CITY PLANNING COMMISSION MEETING

Thursday, April 4, 2013

AGENDA

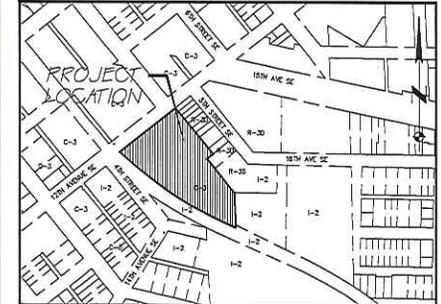
**At its March 19, 2013 meeting, the Design Review Technical Advisory Committee endorsed the request for approval of the site plan and building elevations based on the proposed drawings attached to this report.
The Committee has requested further review of the project as it progresses.**

1. All rooftop mechanical units to be screened.
2. The base wall at the primary entrance of the building should be of a textured material, preferably of higher quality than formed concrete.
3. Further review of the site is requested as the project progresses.
4. Add brick detailing where possible.

A201

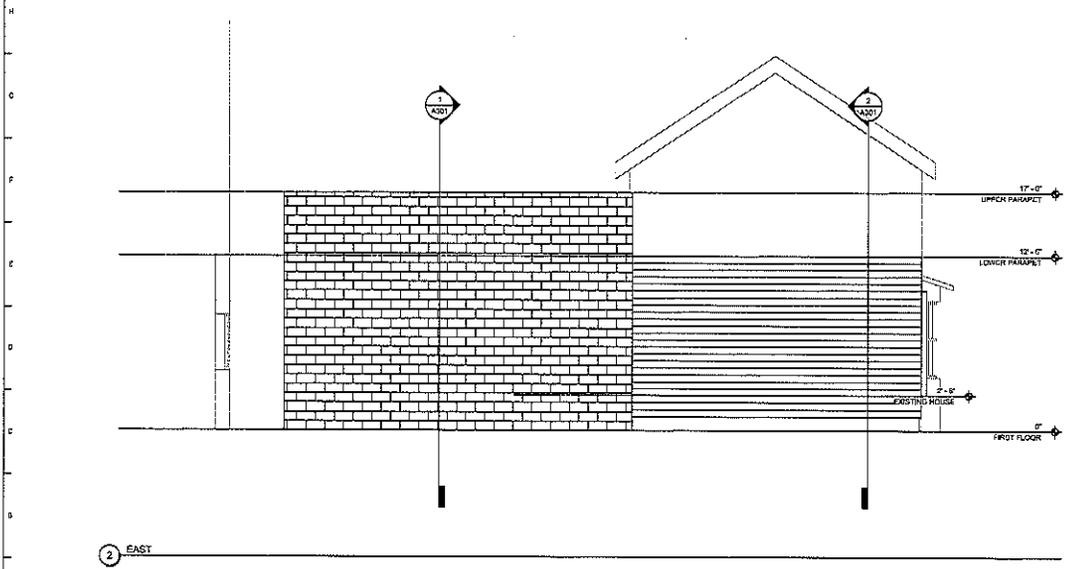
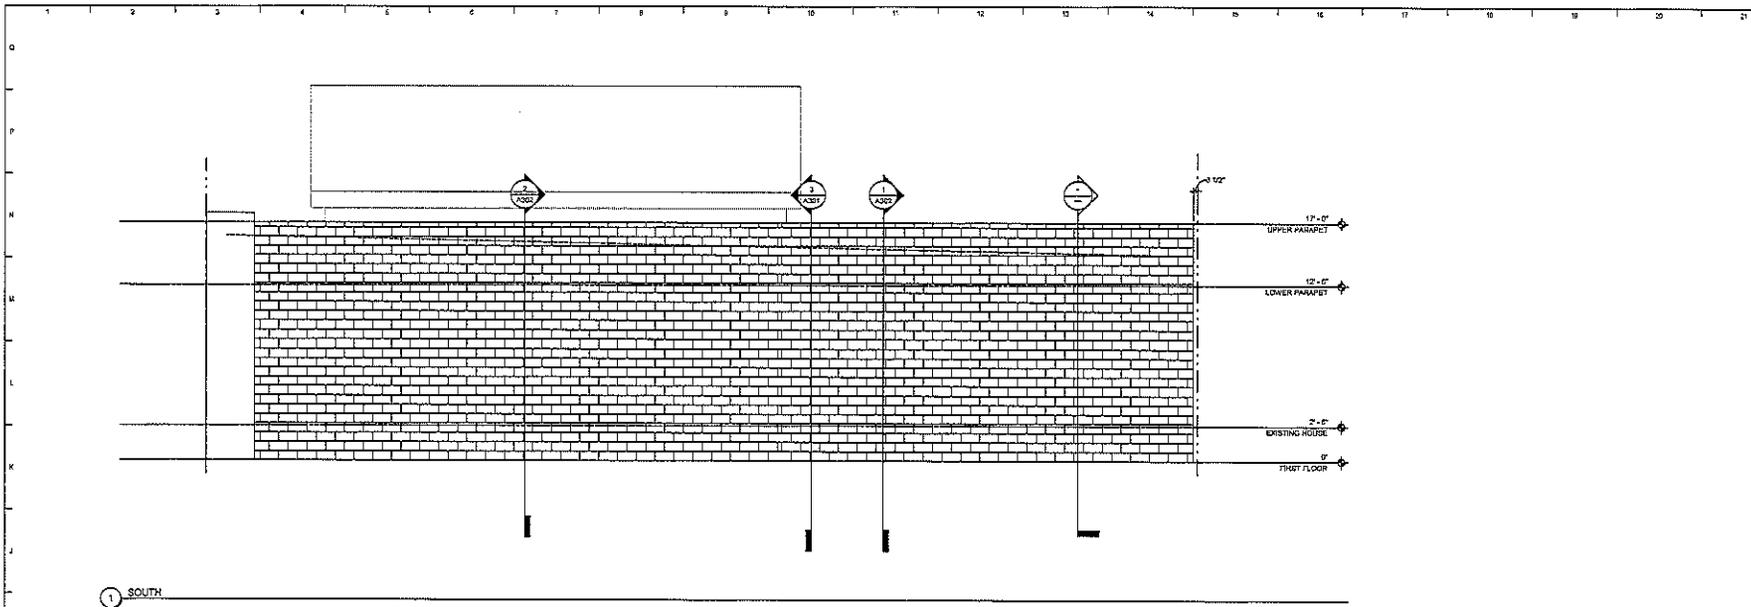
At its December 12, 2012 meeting, the Design Review Technical Advisory Committee endorsed this project based on the proposed drawings attached to this report.

1. No additional items. Elevations and site plan recommended as-is.
